TO: Madeleine Reinke, Kimley-Horn and Associates, Inc.
FROM: Cynthia Thye, Planner 1
DATE: December 31, 2025
SUBJECT: SP25-119: Lincoln Professional Park L2 - 7 Brews Coffee – Site Plan
Review Comments 02

LINCOLN PROFESSIONAL PARK FILING NO. 1
LOT 2, PARKER, CO
7 BREW - SITE PLAN
COVERSHEET

LINCOLN PROFESSIONAL PARK FILING NO. 1
LOT 2, PARKER, CO
7 BREW - SITE PLAN
SITE PLAN

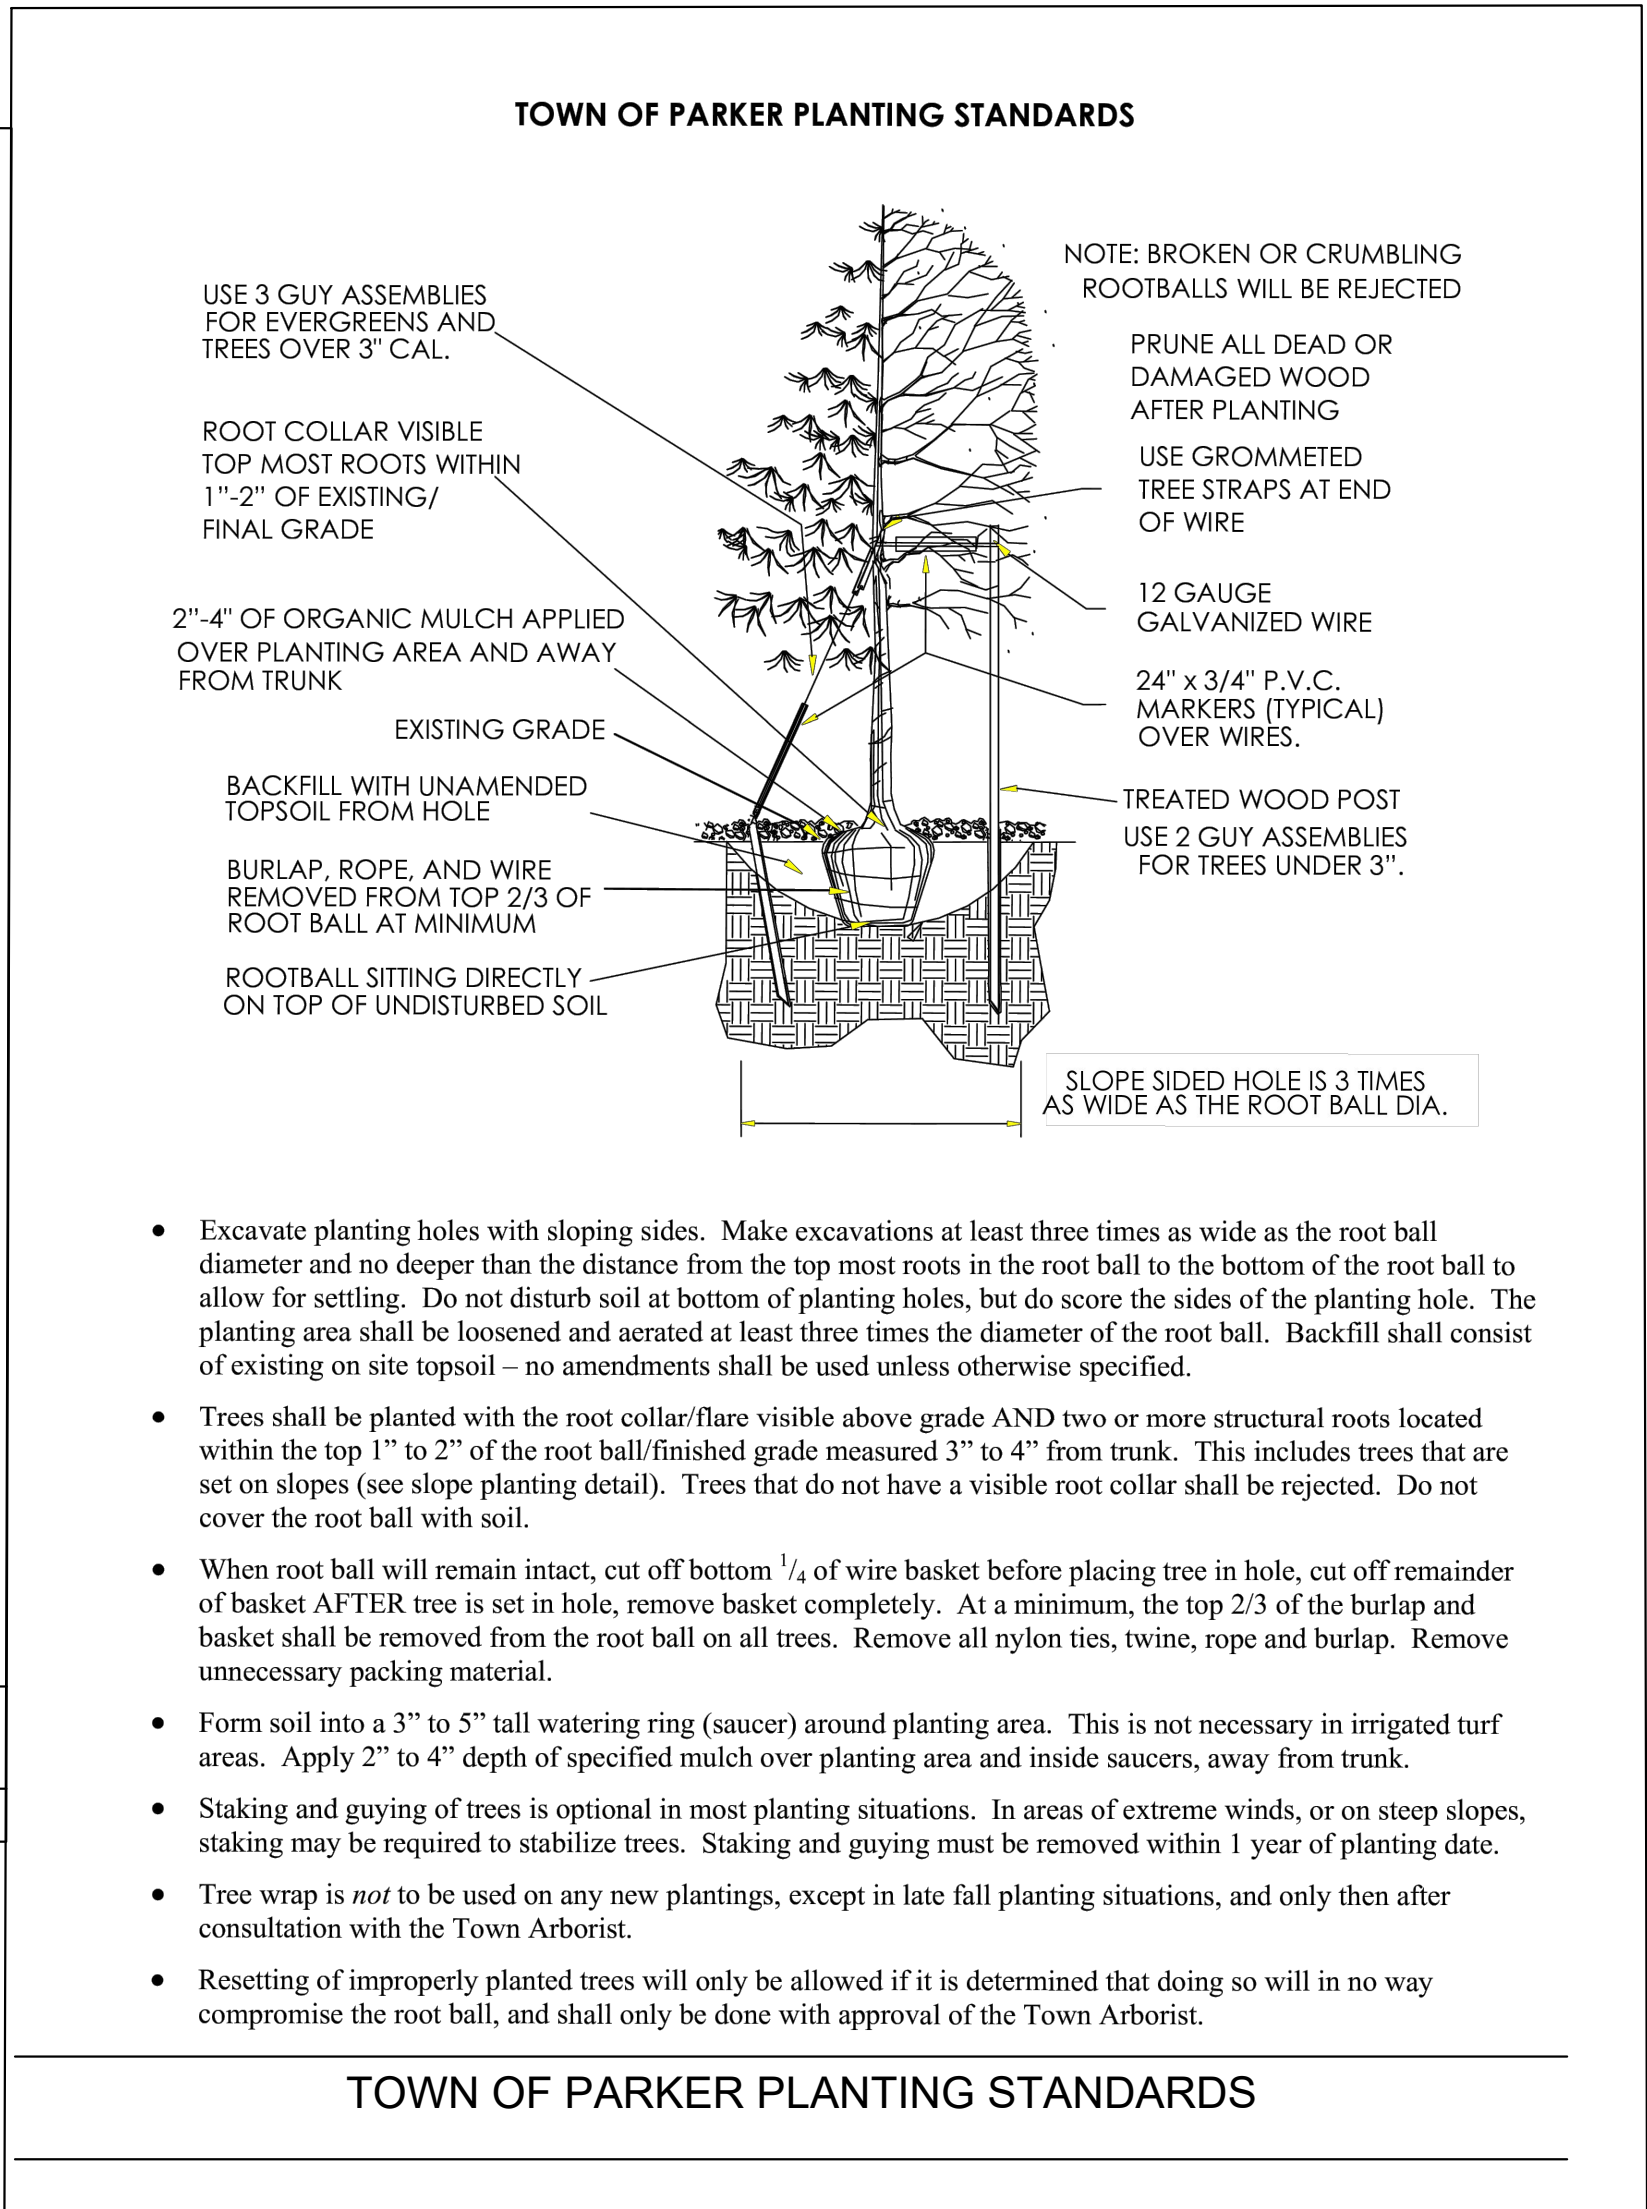
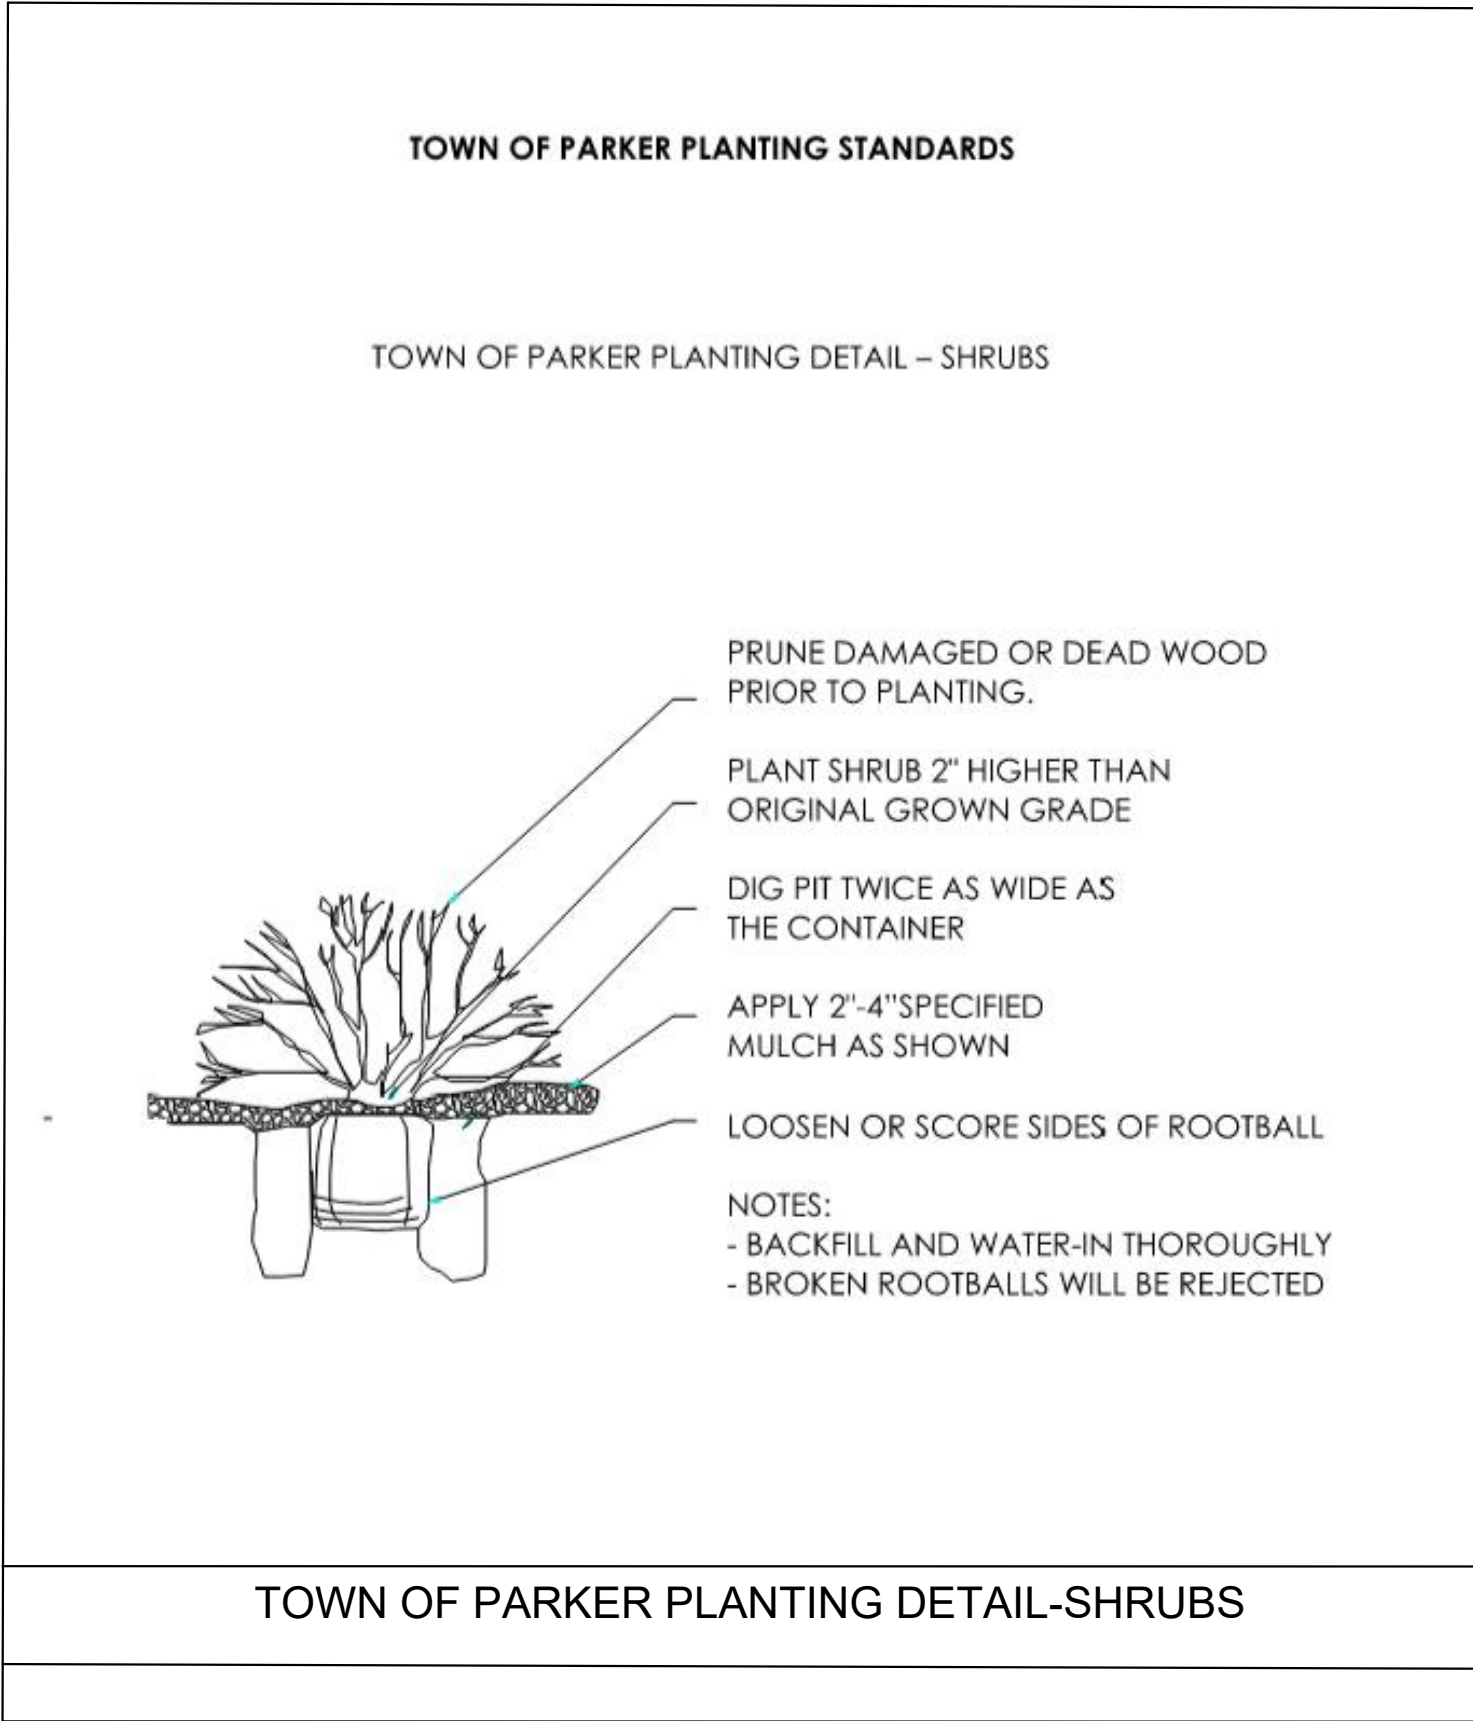
Show any trees provided by developer. Make a note that owner is responsible for maintenance of developer installed streetscape.

KH RESPONSE: Developer landscaping has been added and grayed out

SHEET
L2.0

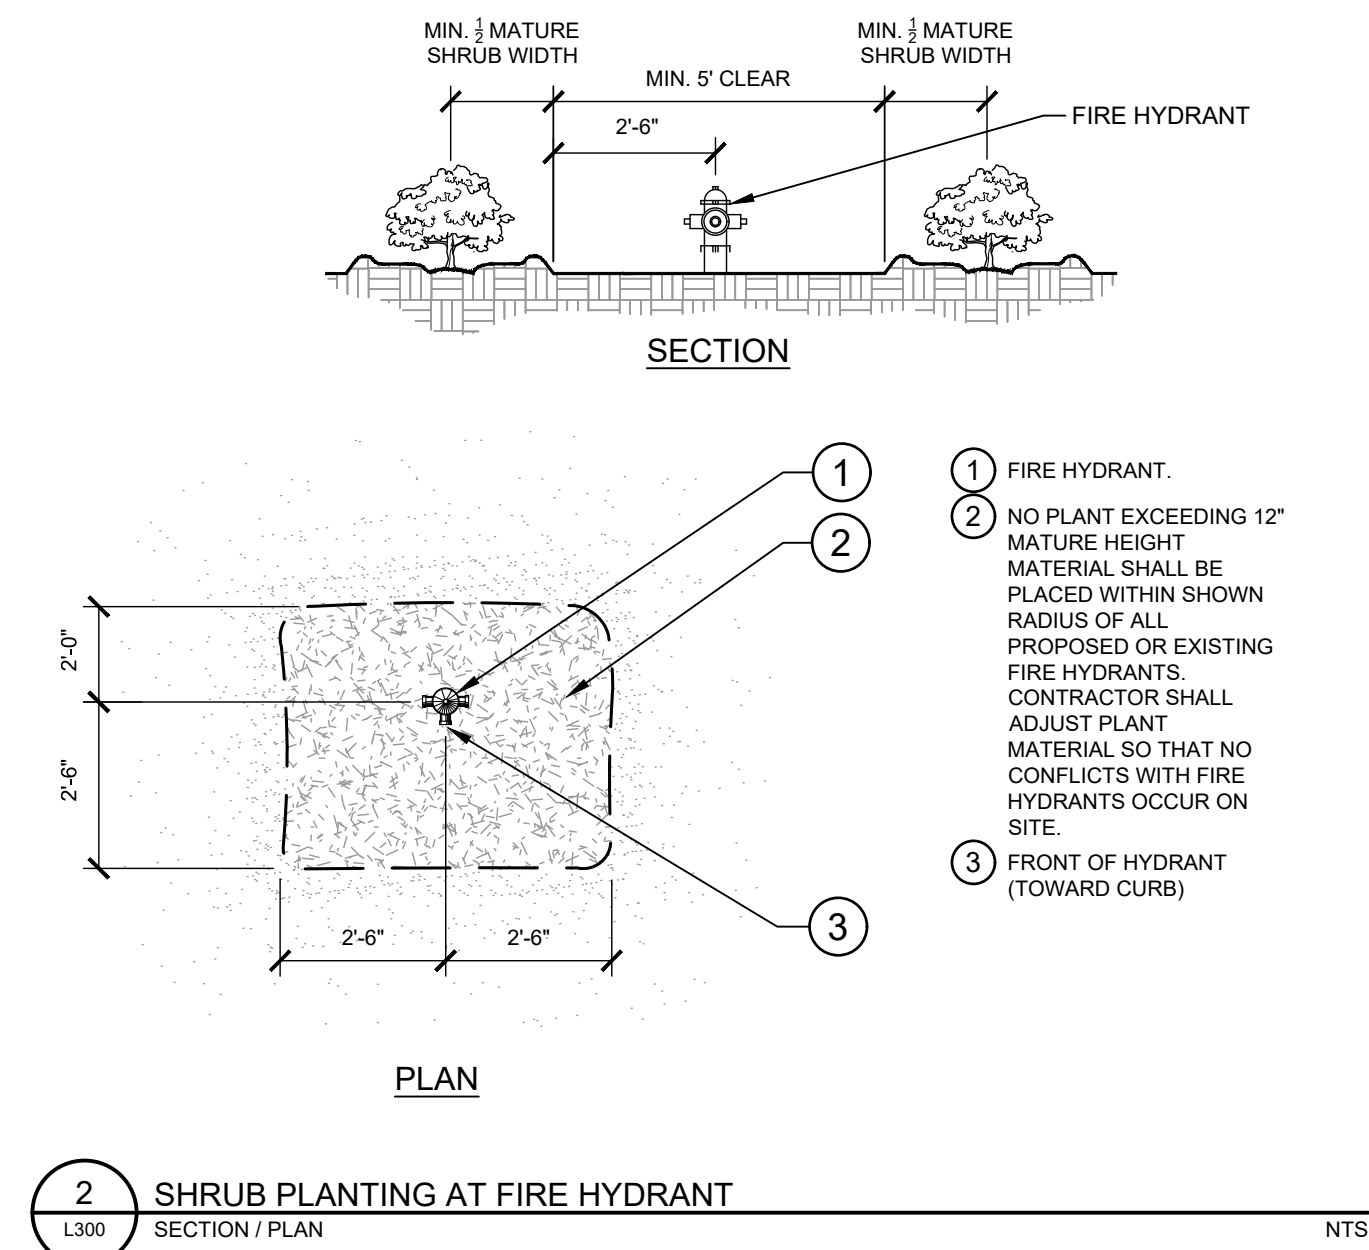
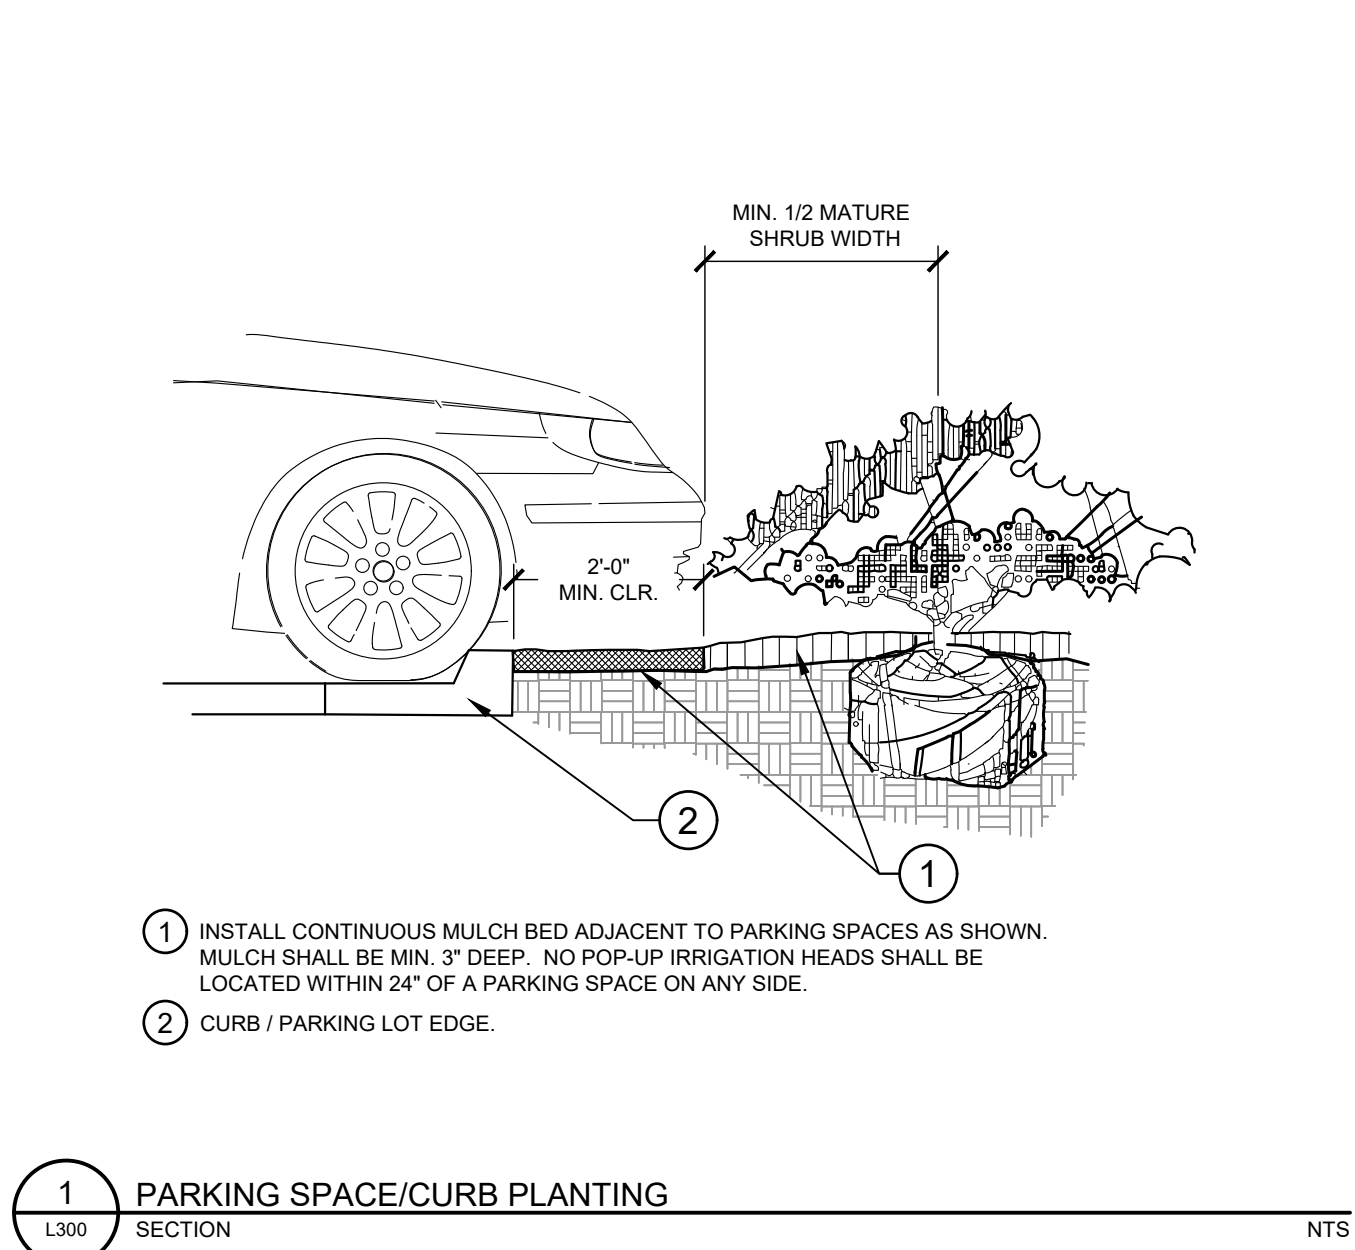
These are not correct. Recalculate.

Add: P1 (this is a min. six foot area per LDO 13.08.090(g)(4).

Revise

Revise - in Mixed Use Community - 1 tree per 40 linear feet.

Per LDO 13.08.090(h) Add Site Interior Landscaping category if parking lot and perimeter landscaping do not collectively meet min. landscaping requirement.

KH RESPONSE: Recalculated

KH RESPONSE: Minimum landscape requirements have been met.
